**Blackmoorfoot Road, Huddersfield  
Proposed Internal Layout (Vistry Parcel)  
Stage 1 Road Safety Audit**

October 2025 (Initial Issue)

Prepared on behalf of  
**Vistry Yorkshire**

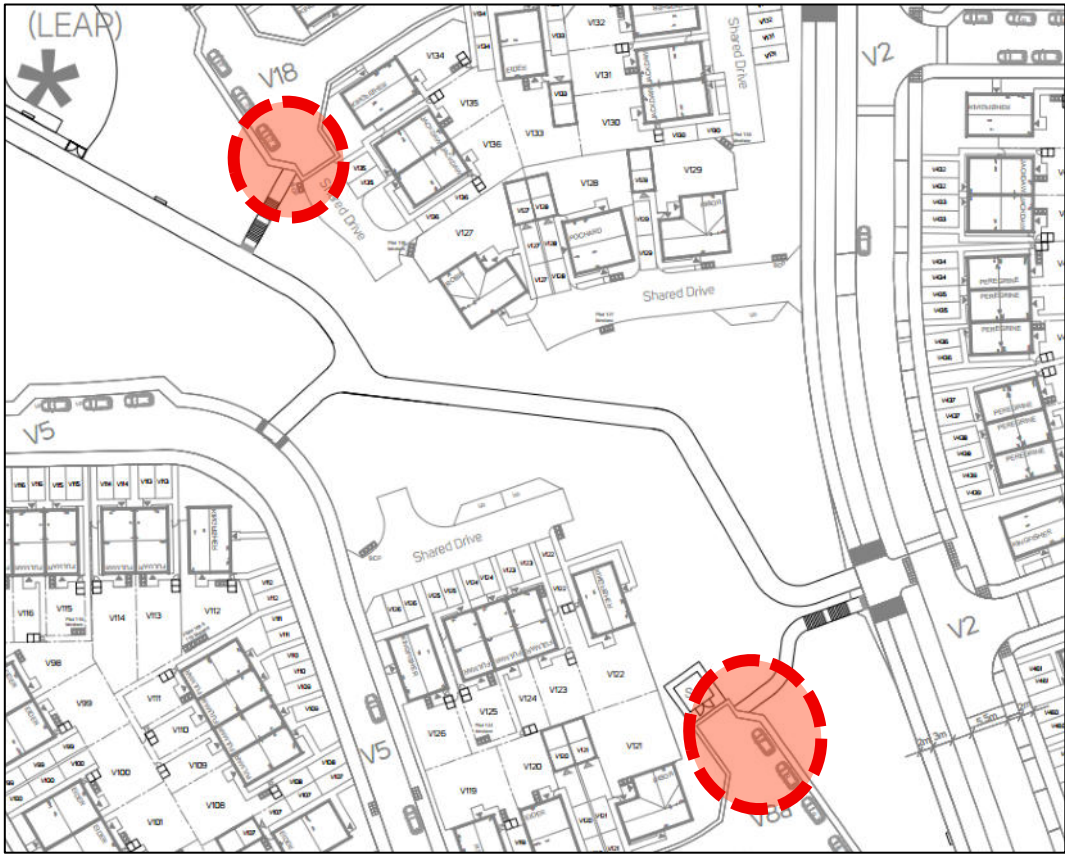
PROBLEM	
<b>Location</b>	Private drive serving plots 10-15 (at the head of Road V3).
<b>Summary</b>	The proximity of the turning head may conflict with users of the shared footway/cycleway.
<p>A private drive serving plots 10-15 forms a turning facility immediately adjacent to the shared footway/cycleway connecting the Millers parcel with Road V3.</p> <p>The proximity of the turning head to the path may result in larger vehicles reversing back onto or overhanging the shared footway/cycleway and increases the risk of a collision with a pedestrian or cyclist.</p>

PROBLEM	
<b>Location</b>	Shared footway/cycle between plots 16 and 10 (Road V3).
<b>Summary</b>	Cyclists may discharge into the carriageway into the path of oncoming traffic.
<p>The shared footway/cycleway connecting the Millers parcel with Road V3 terminates opposite plot 16, where the traditional estate road meets a private drive. The private drive incorporates a formal visitor car parking space, which when occupied, may obstruct visibility to a cyclist when travelling eastbound parallel to one another.</p> <p>Although it is acknowledged that vehicular speeds may be low, the restricted visibility between an eastbound vehicle emerging from the private drive and an eastbound cyclist (particularly a child), could increase the risk of a collision as the cyclist discharges onto the carriageway.</p>

<b>Recommendation</b>	It is recommended that a suitable vehicle restraint barrier is provided between the shared footway/cycle and the turning head. Alternatively, it is recommended that the layout/design of the turning facility is amended to provide adequate separation.

<b>Recommendation</b>	
It is recommended that the visitor parking bay is relocated or removed to provide suitable intervisibility between the private drive and shared footway/cycleway.

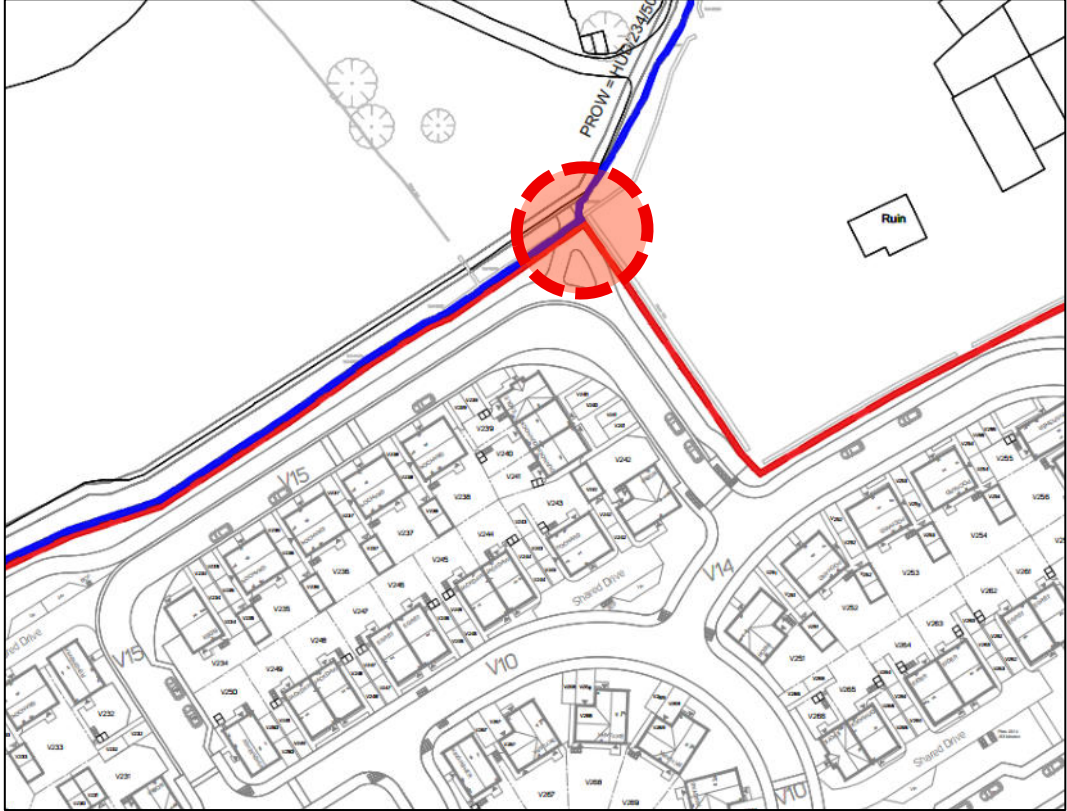
PROBLEM	
<b>Location</b>	Bin collection point adjacent to plot 10 (Road V3).
<b>Summary</b>	The bin collection point restricts visibility from the driveway.
<p>A bin collection point is provided adjacent to plot 10, immediately to the east of the driveway. The bin collection point would be located within the pedestrian intervisibility splay. When occupied, the presence of the bins would likely block visibility between pedestrians on the footway and an emerging vehicle from the driveway, increasing the potential for a collision.</p>	
<b>Recommendation</b>	
<p>It is recommended that the bin collection point to the rear of the substation is enlarged to provide a single bin collection point for plots 10-15.</p>

PROBLEM	
<b>Location</b>	Footpath connection opposite plots 121 and 134.
<b>Summary</b>	A pedestrian may be struck when emerging from the footpaths.
<p>A pedestrian footpath is provided between road V2 and V8a (opposite plot 121) and between road V18 and the play area (opposite plot 134). Both footpaths emerge onto shared surfaces in close proximity to parking laybys and a bin collection point is also located immediately to the east of the connection onto road V18.</p> <p>When occupied, the parking laybys (and bin collection point) are likely to restrict visibility to/from the footpath connection, particularly to smaller children. Although it is acknowledged that speeds will be very low, as reversing vehicles will be a common occurrence within the turning heads, there is a risk of a collision between a pedestrian and reversing vehicles.</p>

<b>Recommendation</b>	
<p>It is recommended that pedestrian visibility splays are provided from the crossing position and the visitor parking bays and bin collection point are relocated accordingly.</p>

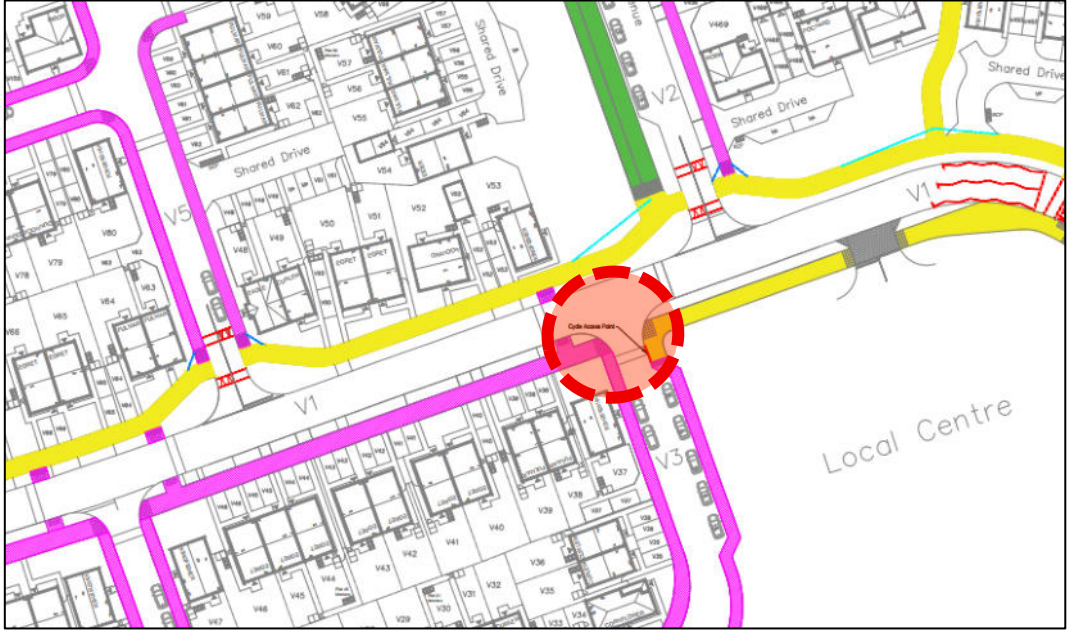
PROBLEM	
<b>Location</b>	Shared surface road V15 opposite plots 234 & 239.
<b>Summary</b>	Parking may occur on the widened margins.
<p>Widened hard margins have been provided on the inside of the two ninety degree bends along road V15, adjacent to plots 234 and 239 in order to accommodate forward visibility.</p> <p>Based on the drawings provided, this appears to be a widened hard margin. The widened area, may be used for parking, which would restrict forward visibility and potentially obstruct larger delivery or refuse vehicles, resulting in a potential vehicle-vehicle or vehicle-pedestrian collision.</p>

<b>Recommendation</b>	
It is recommended that measures are introduced in order to prevent parking within the forward visibility splays at the detailed design stage.
